UNITED STATES PATENT AND TRADEMARK OFFICE

Office Action Summary	Application No. 10/595,342	Applicant(s) HOUEN, TERJE H.	
	Examiner Juan J. Campos	Art Unit 3654

DETAILED ACTION

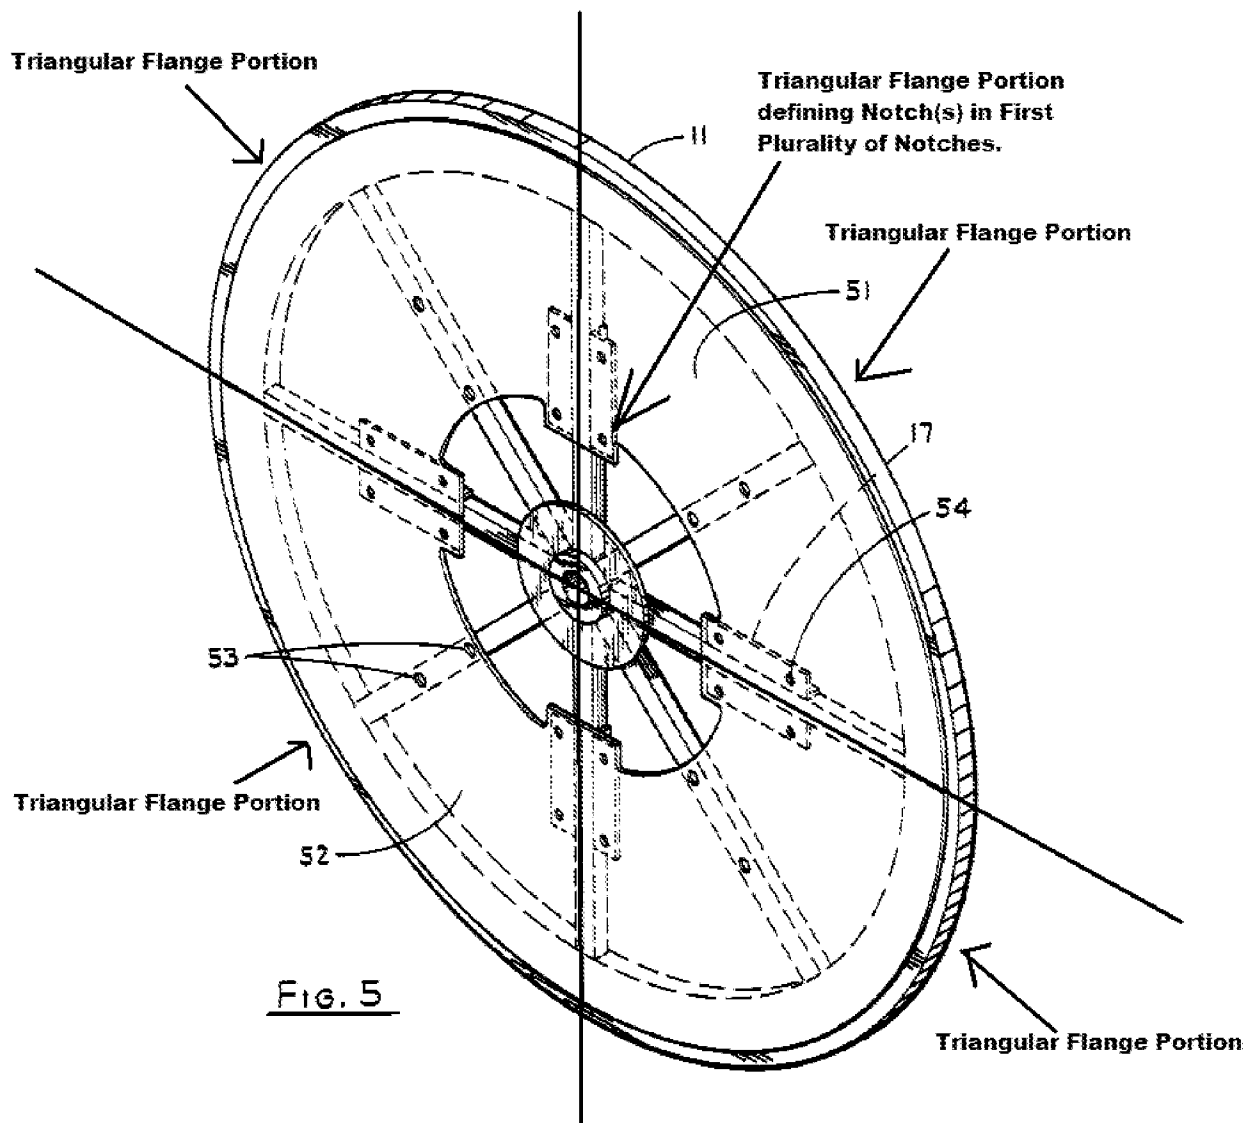
47. Regarding claim 35, Harvey further shows wherein each flange sector 51 is capable of comprising a series of triangular flange portions (see column 5 lines 7-12.

figure 5 and figure below), the triangular flange portions defining notches in the first plurality of notches (see figure 5 and figure below).

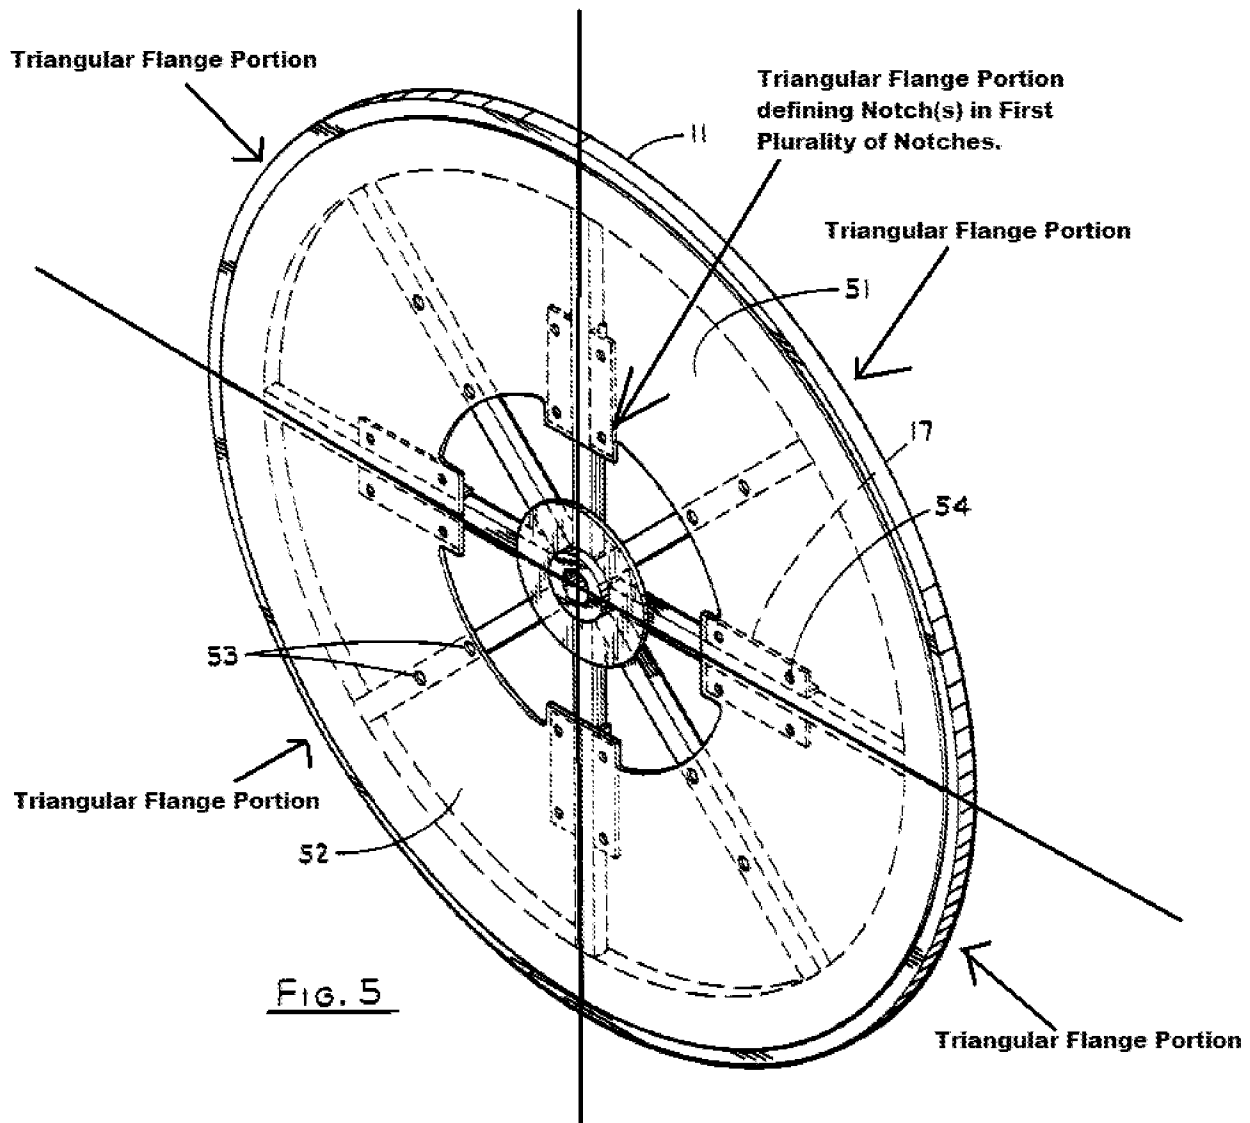
51. Regarding claim 50, Harvey further shows wherein each flange sector 51 is capable of comprising a series of triangular flange portions (see column 5 lines 7-12. figure 5 and figure below), the triangular flange portions defining notches in the first plurality of notches (see figure 5 and figure below).
